PART 573 Defect and Noncompliance Report 99V-090 (01)

DMC Recall Identification Number: EBB-001-99

RECALL SERVICE BULLETIN

Bulletin No.	RSB-001-99	Description	Door Pad Positioning
Model(s)	1998-99 Lanos 3-Door	Group	Campaigns
Date	May 7, 1999	Reference	T99-9-01
VIN Range	KLATC2261WB158465 ~ KLATA2265XB377719	Prod. Dates	10/10/97 ~ 3/15/99

DOOR PAD POSITIONING PROCEDURE

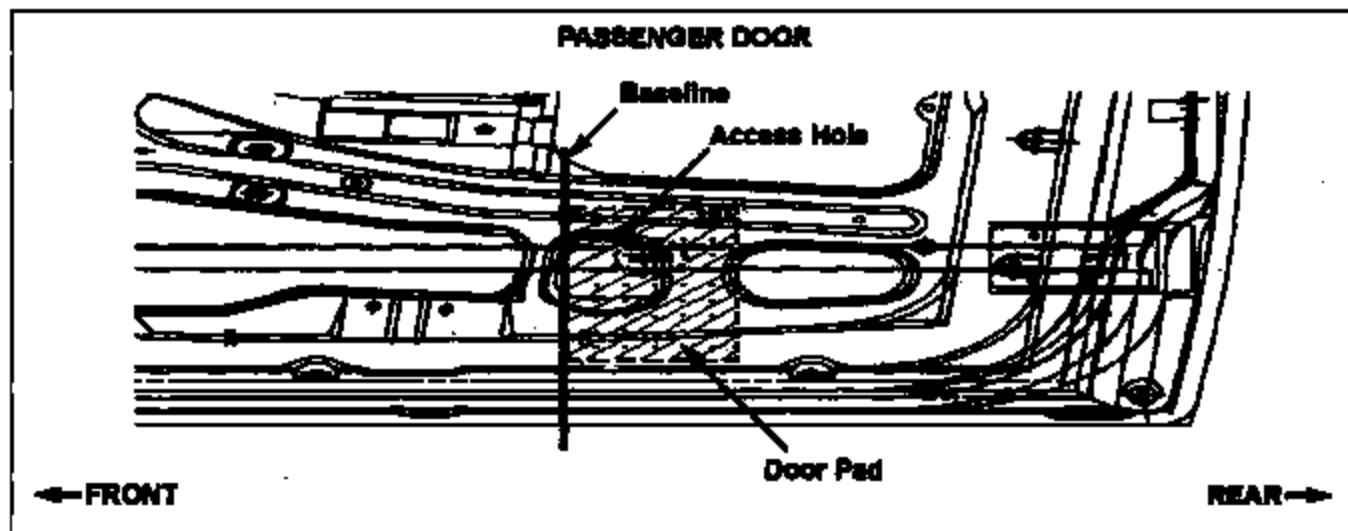
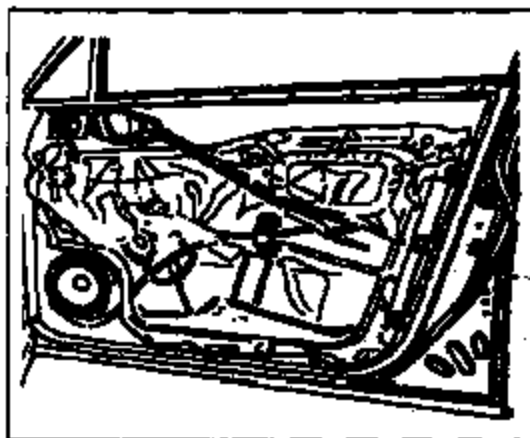
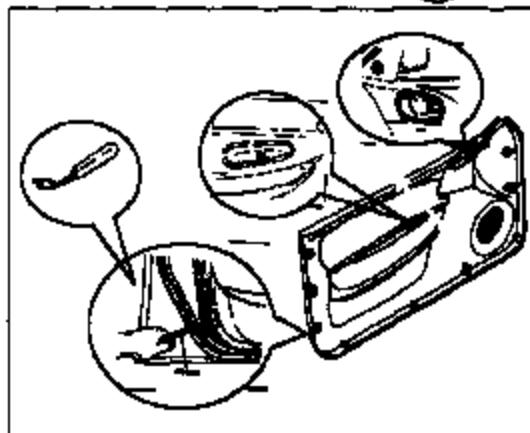
In specific Lanos 3 Door Hatchback models, the Door Pad is incorrectly positioned during the vehicle manufacturing process near the door latch mechanism (rearward in the door assembly). In Lanos 3 Door Hatchback models that have been correctly manufactured, the Door Pad is positioned mid door (refer to attached Manufacturing Standard Drawing).

6. Verify that the door pad is correctly positioned according to the illustration provided above. If the door pad is not positioned correctly, slide the door pad along the tubular side impact beam until the correct position is achieved.
7. Reinstall the plastic moisture barrier, door panel, retaining screws, window crank handle (if equipped) and door trim items.
8. Roll the window up and down and insure the correct operation and positioning of the window and door handles.

1. Remove the four (4) door panel retaining screws.
2. Using a suitable door panel removal tool, remove the side mirror interior trim panel and the inner door release handle trim bezel.
3. **Lanos S models only** - Using a suitable release tool, remove the retaining clip and remove the window crank handle.
4. Using a suitable door panel removal tool, carefully release the door panel retaining clips and remove the door panel from the door.
5. Starting from the rear of the door, carefully remove the plastic moisture barrier from the rear portion of the door until the center of the door is exposed.

Diagram 1

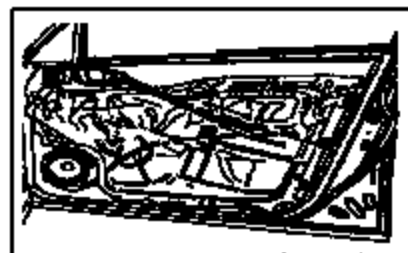
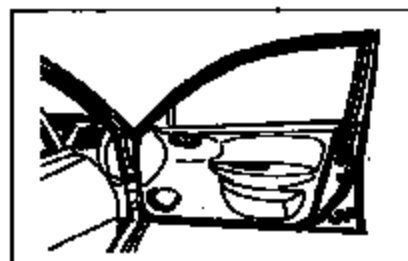
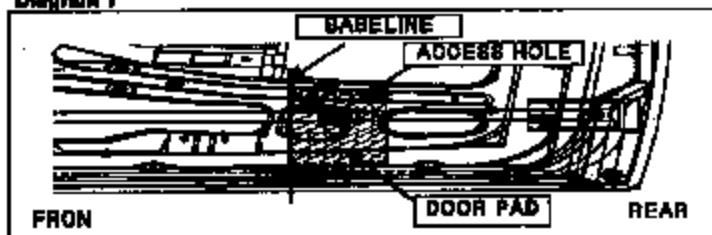
Recently, it was reported the Side Impact Protection Door Pad was incorrectly installed or missed in some Lanos 3-Door Hatchback and 4-Door Notchback models.

1. Door Trim Panel Removal:
 - a. Lower the front window.
 - b. Remove the door pull screw.
 - c. Pry off the Inside Door Handle Trim Bezel.
 - d. Remove the screws on the base of the Trim Panel.
 - e. Pry off the Trim Panel using the Door Trim Remover (KM-475-B).
2. Remove the door screws and the pull bracket.
3. Remove the Door Seal Trim.
4. Inspect the position of the Door Pad in the front Door Panel. Relocate the Door Pad to the end of the part of access hole as shown in the diagram 1.
5. After completion of the repair place a punch mark above the second digit of the VIN (in this case over the letter "L") stamped into the Bulkhead in the engine compartment.

Diagram 2

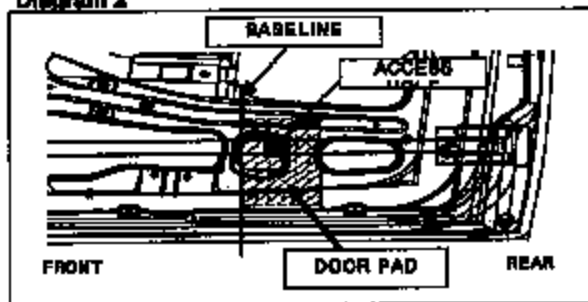
In specific Lanos 3-door Hatchback models, the Door Pad was not inserted during the vehicle assembly process near the door latch mechanism (rearward in the door assembly). In Lanos 3 door Hatchback models that have been correctly manufactured, the Door Pad is positioned mid door (refer to attached Manufacturing Standard Drawing). In certain 4-door models, Door Pad is not installed and mispositioned. (refer to the attached Manufacturing Standard Drawing)

1. Remove the Door Trim Panel (see instructions explained above).
2. Install the Door Pad as shown in the diagram 2. When installing the Door Pad for the 4-Door Notchback, set the Door Pad end to the contact Point. (See diagram 3)
3. After completion of the repair place a punch mark above the first digit of the VIN (in this case over the letter "K") stamped into the Bulkhead in the engine compartment

Diagram 3

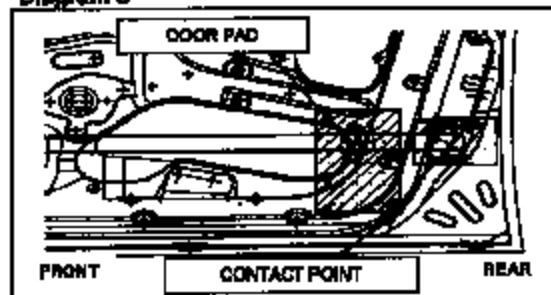
For 4-door model, Door Pad is located in the end-door position.

* ADDITION OF DOOR PAD (3DOOR H/B, 4DOOR N/B)

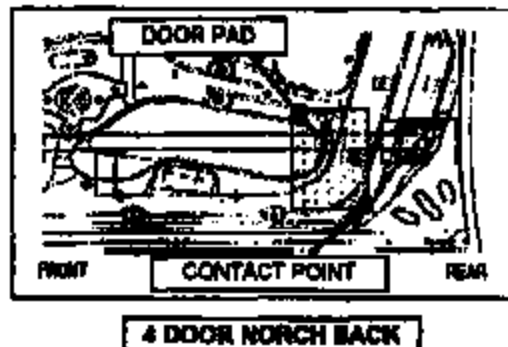
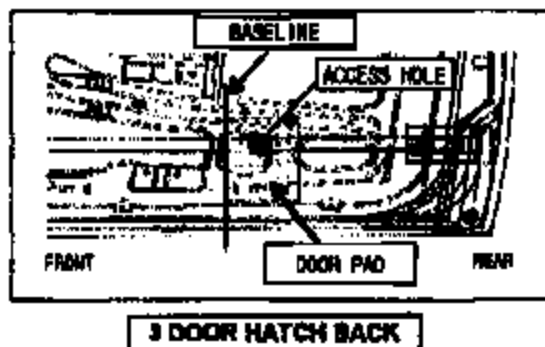
5. If the door pad have been missed, install the door pad as follows.

- when installing the door pad to 4 door norch back model, set the end part of door pad to the contact point.
